Rezoning Transportation Analysis

Petition Number: 2017-103

General Location Identifier: 12304112

Date	Description
07-24-17	First Review

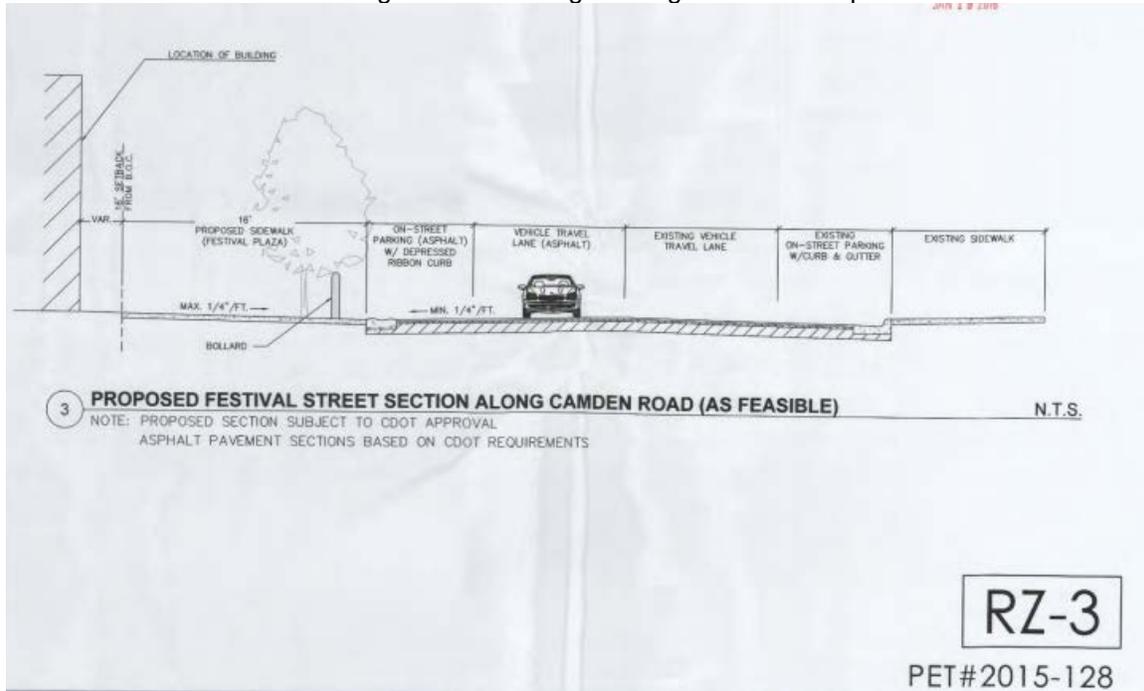
- Curbline** The proposed zoning district has a setback measured from back of the existing or proposed future curbline.
 - The petitioner should revise the site plan to show the curb and gutter at the corner of Camden Rd and E. Park Av be rebuilt to have a smaller radius and creating a bump out. This would turn the existing on-street parking into recessed parking and would match the parking across the street.
 - The petitioner should revise the site plan to show Camden Rd as the envisioned festival street (woonerf) matching the cross section approved across the street (Rezoning 2015-128) where/as new construction or redevelopment occurs. This section of Camden Rd is
